CITY OF ALBUQUERQUE

**Re: Broadstone Promenade Phase 18, 20 & 21
7400 San Pedro Dr. NE
Permanent CO – Accepted
Engineer's Stamp dated: 5-26-15 (D18D054A)
Certification dated: 5-26-16**

DRAINAGE CERTIFICATION

OVERALL  
GRADING AND DRAINAGE PLAN

**CG1.1**

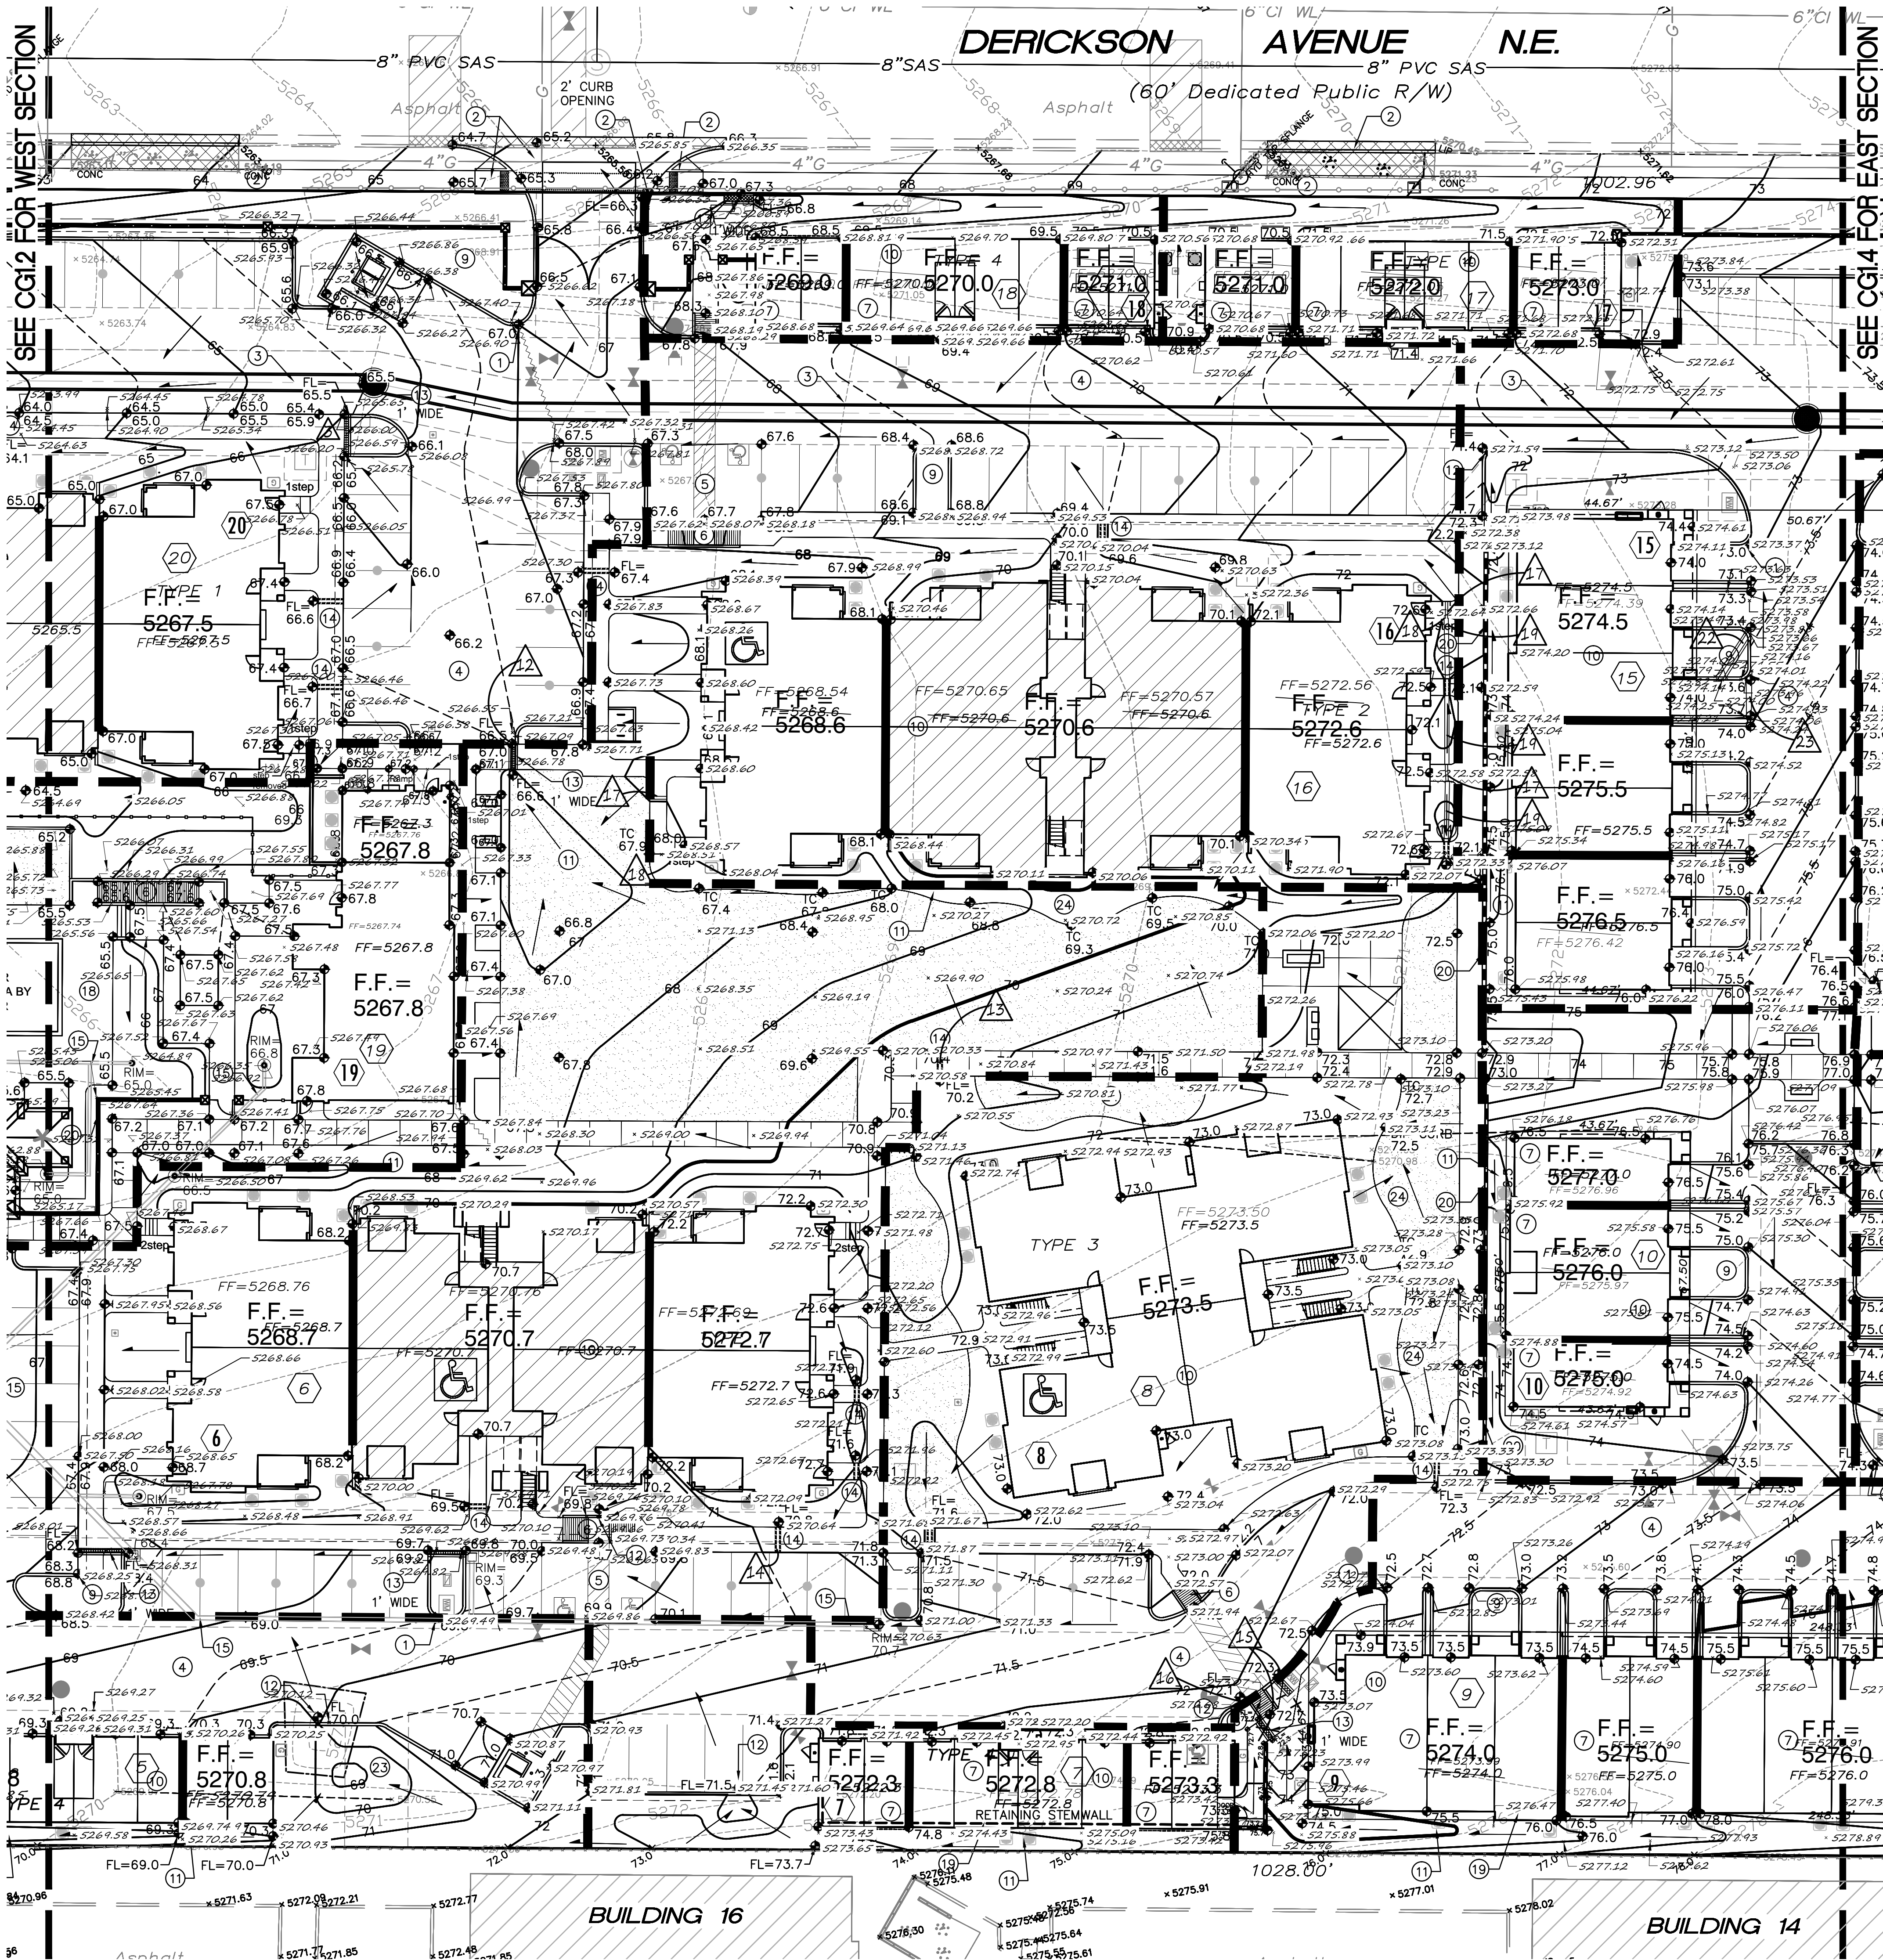
- △ SIDEWALK CULVERT NOT CONSTRUCTED. CULVERT SHALL BE CONSTRUCTED PRIOR TO CERTIFICATION OF BUILDING 2.

- △ LOWER/ADJUST STORM DRAIN GRATES TO GRADE, TO BE VERIFIED PRIOR TO CERTIFICATION OF PHASE 3.

- △ INSTALLATION OF SIDEWALK CULVERT OR PVC PIPES TO BE VERIFIED PRIOR TO CERTIFICATION OF PHASE 4.

- △ GRADING OF SLOPE TO BE VERIFIED PRIOR TO CERTIFICATION OF PHASE 4.

- △ COMPLETION OF ITEMS FROM PHASES 3 & 5 TO BE VERIFIED PRIOR TO FINAL CERTIFICATION.

- △ INSTALLATION OF 4" PVC PIPES TO BE VERIFIED PRIOR TO FINAL CERTIFICATION.

- △ LANDSCAPING TO BE ADJUSTED SUCH THAT A SWALE DIRECTS STORM WATER TO PIPES OR SIDEWALK CULVERTS AND THAT TOP OF MATERIAL IS AT INVERT OF PIPE OR CULVERT TO ALLOW FOR FLOW THROUGH. UNDER NO CIRCUMSTANCES SHOULD THE ENDS OF PIPES OR CULVERTS BE BURIED. THIS SHALL BE VERIFIED PRIOR TO FINAL CERTIFICATION.

- △ OBTAIN ADDITIONAL AS-BUILT SPOTS TO ALLOW FOR VERIFICATION OF DRAINAGE PATHS AND SLOPES PRIOR TO FINAL CERTIFICATION.

- △ GRADE A DEFINED SWALE/OVERFLOW PATH TO BOTTOM OF SIDEWALK CULVERT AND LINE SWALE WITH FRACTURED FACE ROCK. TOP OF ROCK ELEVATION SHALL BE AT INVERT OF CULVERT.

- △ LOWER INLET 0.5'.

- △ CONSTRUCTION OF ITEMS 8 & 9 SHALL BE COMPLETED BEFORE CERTIFICATION OF PHASE 7.

- △ 4" PIPES INSTALLED THROUGH SIDEWALKS.

- △ RIM ELEVATION OF INLET (ITEM 8) SHALL BE VERIFIED PRIOR TO FINAL CERTIFICATION.

- △ SIDEWALK CULVERT SHALL BE CONSTRUCTED PRIOR TO PHASE 10 CERTIFICATION.

- △ DRAIN PIPES SHALL BE INSTALLED PRIOR TO PHASE 10 CERTIFICATION.

- △ CHIPPED SIDEWALK CONCRETE AND DEFORMED DRAINAGE PIPES. DRAIN PIPES SHALL BE REINSTALLED PRIOR TO FINAL CERTIFICATION.

- △ SIDEWALK MODIFICATION AND SIDEWALK CULVERT RELOCATION.

- △ CURB OPENING NOT INSTALLED---NOT NEEDED AFTER THE SIDEWALK MODIFICATION AND SIDEWALK CULVERT RELOCATION.

- △ 2 DRAIN PIPES INSTALLED

- △ STEP NOT CONSTRUCTED

- △ 12" VALLEY GUTTER CONSTRUCTED

- △ DRIVEWAY SLOPE SHALL BE VERIFIED AND PAVING SHALL BE ADJUSTED IF NEEDED TO ENSURE THERE IS NO PONDING PRIOR TO FINAL CERTIFICATION.

- △ MEDIAN WAS SHIFTED EAST.

- △ 12" PCC RUNDOWN CONSTRUCTED.

- △ PCC HUMP CONSTRUCTED TO PREVENT WATER FROM ENTERING BUILDING BECAUSE DRIVING AISLE PAVING WAS INSTALLED TOO HIGH.
